10GBASE-T Transmitter PSD

Sandeep Gupta (Teranetics), Ramin Shirani (Aquantia)

PSD curves with assumptions as stated

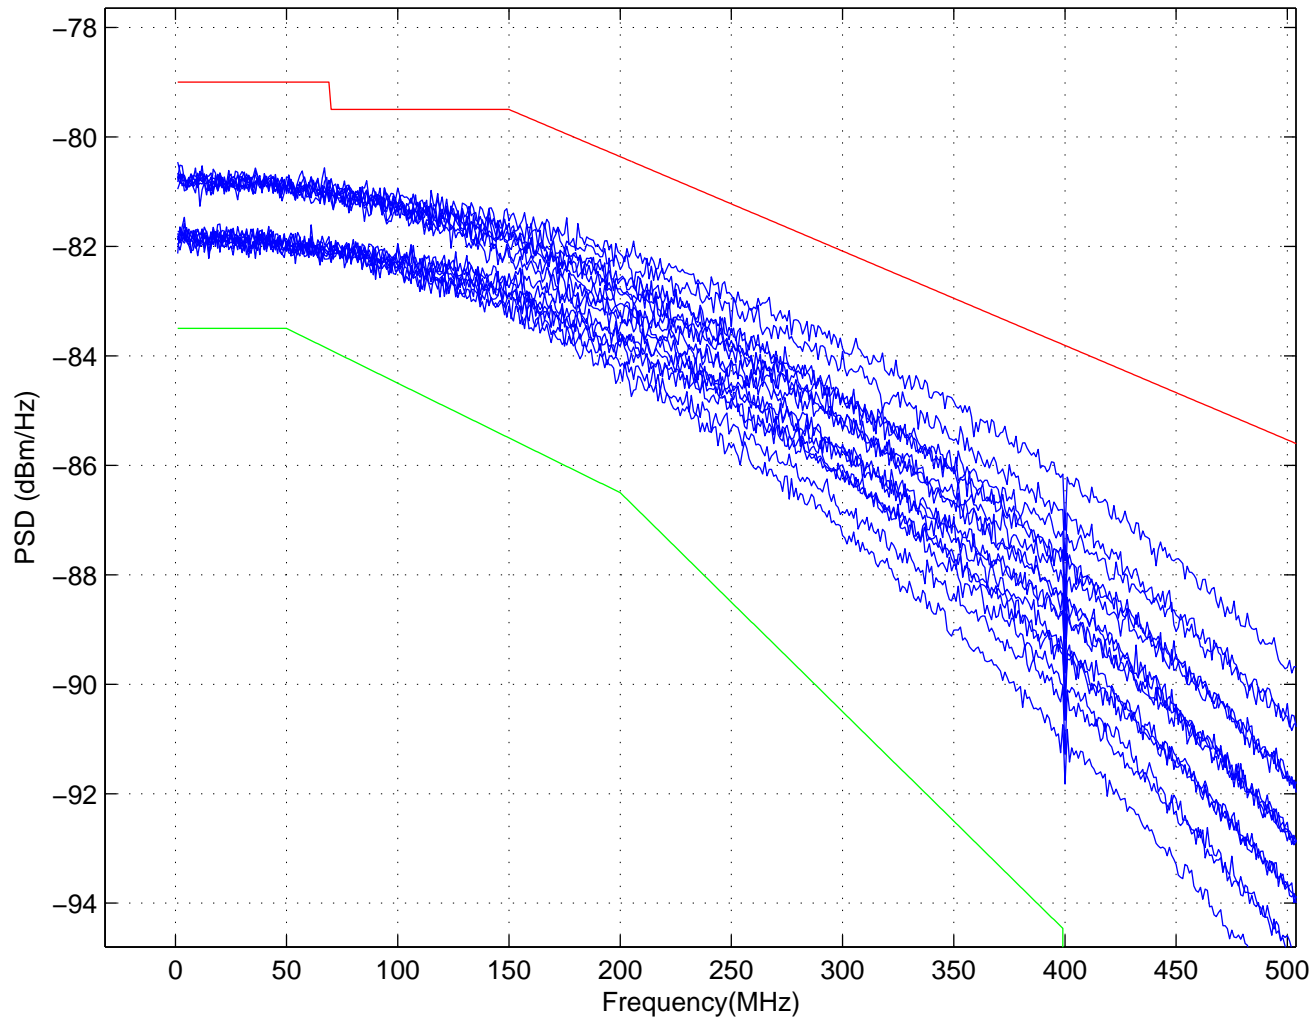
- With 2V +/- 6% at the transformer output, the lower PSD curve has smaller margin at lower end.
- 2V +/- 6% with the filter tolerances as specified meets the power spec
- Upper PSD has a larger margin, especially the lower 0-70MHz range.

Reduce the upper PSD by 1dB in 0-70MHz.

0.5dB reduction on upper and lower curves everywhere else w.r.t. draft 2.1, would make it better centered.

PSD upper curve:

- 79 dBm/Hz, $0 < f \leq 70$**
- 79.5 dBm/Hz, $70 < f \leq 150$**
- $-79.5 - (f - 150)/58$ dBm/Hz, $150 < f \leq 730$**
- $-79.5 - (f - 330)/40$ dBm/Hz, $730 < f \leq 1810$**
- 116 dBm/Hz, $1810 < f < 3000$**

PSD lower curve:

- 83.5 dBm/Hz, $5 < f \leq 50$**
- $-83.5 - (f - 50)/50$ dBm/Hz, $50 < f \leq 200$**
- $-86.5 - (f - 200)/25$ dBm/Hz, $200 < f \leq 400$**
